UNITED STATES PATENT AND TRADEMARK OFFICE

APPLICATION NO.	FILING DATE	FIRST NAMED INVENTOR	ATTORNEY DOCKET NO.	CONFIRMATION NO.
10/816,697	04/05/2004	Richard Scott Bourgeois	126533-1	9731
6:147 7590 03/17/2008 GENERAL ELECTRIC COMPANY GLOBAL RESEARCH PATENT DOCKET RM. BLDG. K1-4A59 NISKAYUNA, NY 12309				
EXAMINER CHUO, TONY SHENG HSIANG				
ART UNIT		PAPER NUMBER		
1795				
NOTIFICATION DATE		DELIVERY MODE		
03/17/2008		ELECTRONIC

Office Action Summary

DETAILED ACTION

FIG. 1

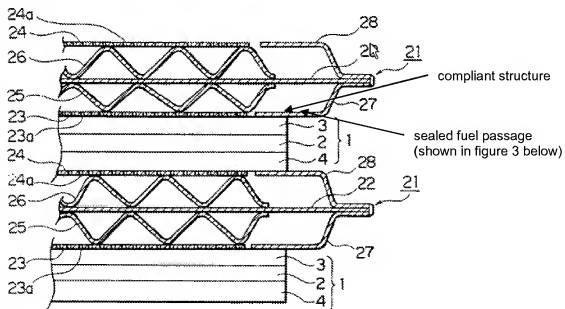
Regarding claim 19 and 34, the Sasaki reference discloses a fuel cell stack comprising: a first fuel cell assembly "1" & "21" and a second fuel cell assembly "1" & "21" electrically coupled together such that sealed manifolds extend between the first and second fuel cell assemblies, each first and second fuel cell assembly comprising: a hollow manifold comprising a top wall "22" and a bottom wall "23" & "27", wherein each of the top and bottom walls include a sealed fuel passage for allowing fuel to enter and

exit the hollow manifold; and a fuel cell "1" comprising an anode "3", a cathode "2", and an electrolyte "4" disposed there between, wherein the fuel cell "1" is disposed on the bottom wall "23" & "27" between the at least one manifold, wherein the bottom wall "23" & "27" of the at least one hollow manifold extending between the fuel cell and the sealed fuel passage includes thin plates "27" that are rich with flexibility to accommodate strain therebetween (See Figures 1 and 3, column 5 line 40 to column 6 lines 9-16, and column 7, lines 3-11).

Examiner's note: The Sasaki reference discloses gas inlet manifold and gas outlet manifold (not shown in Figure 1), located left and right of the fuel cell, are construed as being sealed fuel passages (See Figures 1 and 3 and column 7, lines 3-11). Therefore, the thin plates "27" are located adjacent to the fuel cell and the sealed passage.

Regarding claim 20, it also discloses a cathode flow channel coupled to the hollow manifold of the first fuel cell assembly and the second fuel cell assembly that is configured for directing an oxidant between the first fuel cell assembly and the second fuel cell assembly (See Figure 1).

Regarding claim 21, it also discloses a hollow manifold that is substantially rectangular (See Figure 1).

Regarding claims 32 and 33, it also disclose the top wall "22" and bottom wall "23" of the hollow manifold that act as an anode interconnect (See Figure 1).
